Contract #: 04-0120F4Cty: SF/ALA Rte: 80 PM: 13.2/13.9File #: 69.28**WELDING INSPECTION REPORT****Resident Engineer:**Pursell, Gary**Address:** 333 Burma Road**City:** Oakland, CA 94607**Report No:** WIR-002703**Date Inspected:** 26-May-2008**Project Name:** SAS Superstructure**OSM Arrival Time:** 700**Prime Contractor:** American Bridge/Fluor Enterprises, a JV**OSM Departure Time:** 1700**Contractor:** Zhenhua Port Machinery Company, Ltd (ZPMC), Changxing Island **Location:** Shanghai, China**CWI Name:** Sun Wei**CWI Present:** Yes No**Inspected CWI report:** Yes No N/A**Rod Oven in Use:** Yes No N/A**Electrode to specification:** Yes No N/A**Weld Procedures Followed:** Yes No N/A**Qualified Welders:** Yes No N/A**Verified Joint Fit-up:** Yes No N/A**Approved Drawings:** Yes No N/A**Approved WPS:** Yes No N/A**Delayed / Cancelled:** Yes No N/A**Bridge No:** 34-0006**Component:** OBG**Summary of Items Observed:**

**Production Monitoring Test**

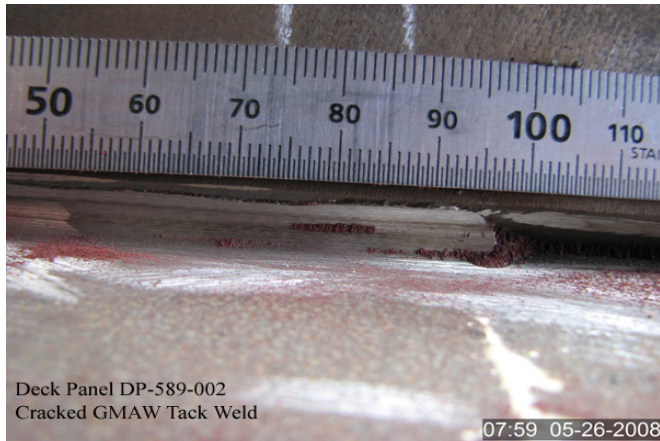
The Quality Assurance Inspector performed magnetic particle inspection to the tack welds on weld 8 of Deck Panel DP-589-002. Weld 8 contains 24 tack welds. Of the 24 tack welds, 16 appeared to contain linear indications indicative of cracks. ABF representative Warren Buehler was notified by the Quality Assurance Inspector. Mr. Buehler stated that ABF has recommended that all the tack welds be magnetic particle tested. At completion of the Quality Assurance Inspectors shift ABF had begun magnetic particle testing weld 8. Below are two digital photographs of cracked GMAW tack welds located by the magnetic particle testing method.
